Local Government Insurance Service  
Preliminary Liability Risk Advice  
Wilson Park, Mount Barker

**Preliminary Liability Risk Advice: Wilson Park, Mount Barker.**

**Shire of Plantagenet Wilson Park Site Inspection Photographs & Comments**

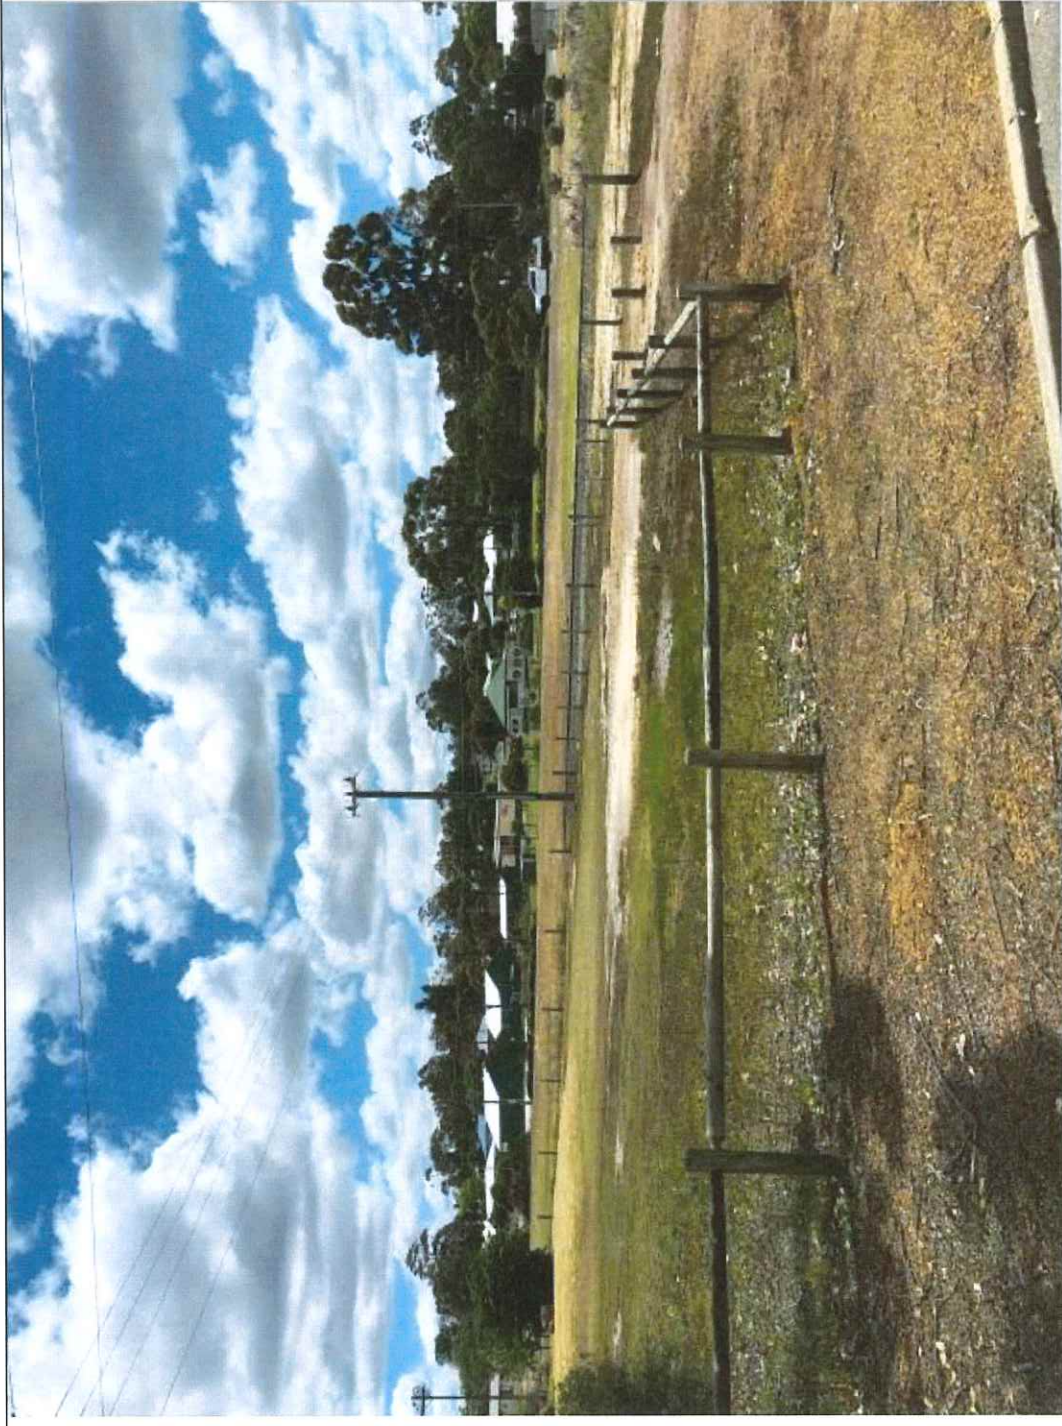
South east corner of Wilson Park indicating rail line and commencement of treated pine fence to Montem Street. Some minor repair work is required to the steel wire to the fencing as it angles away from the rail line.

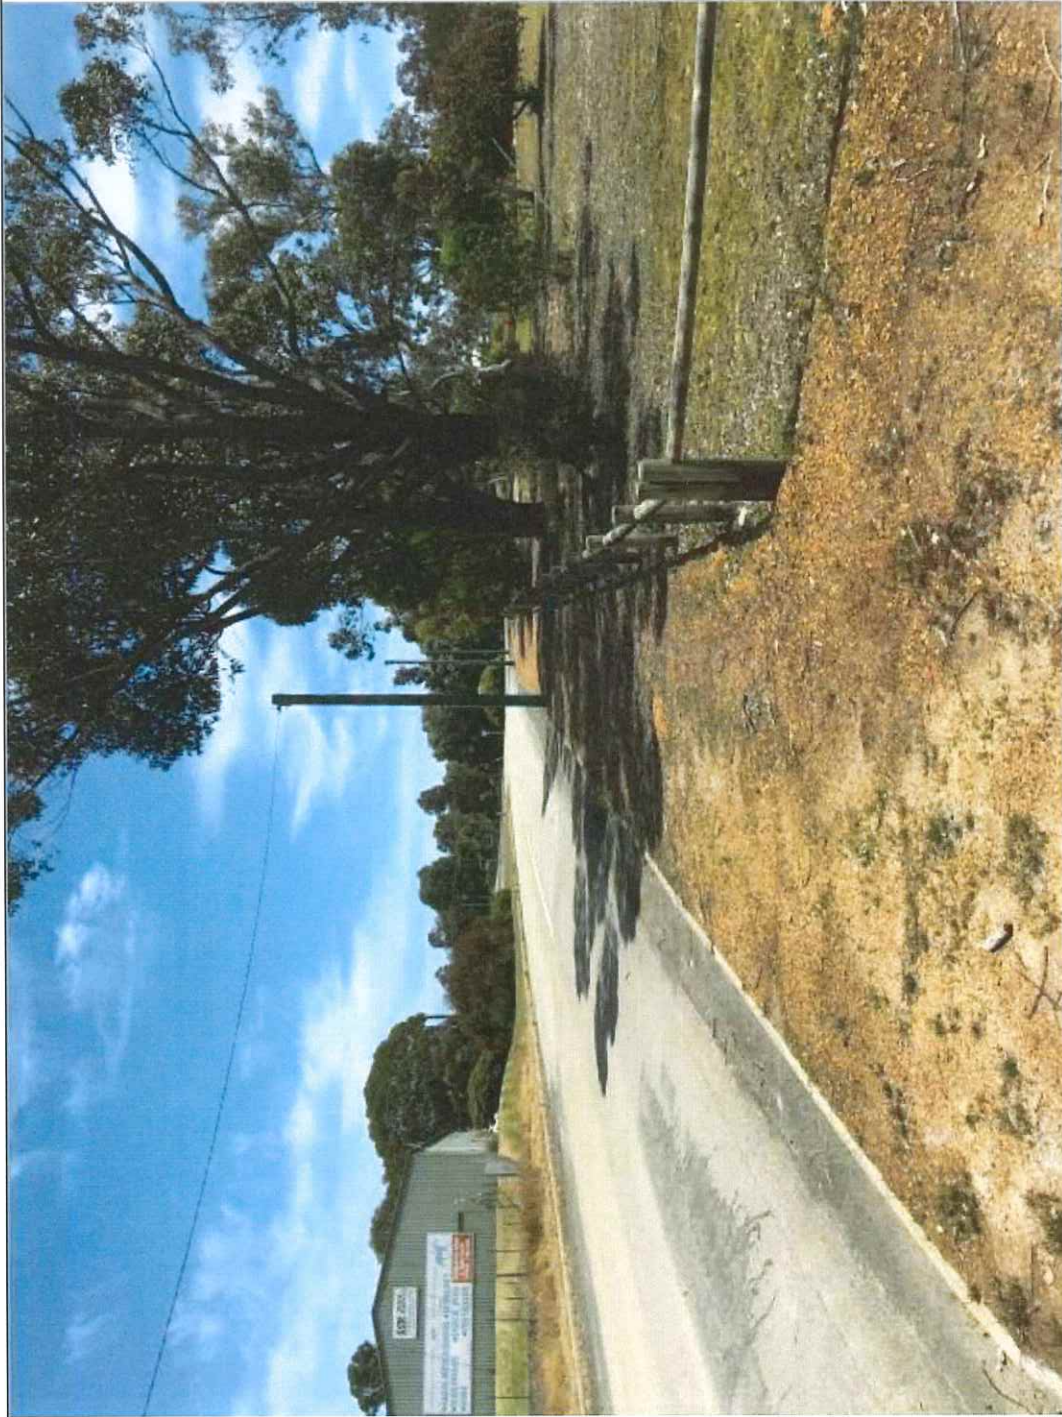
Nature of fencing to Montem Street.
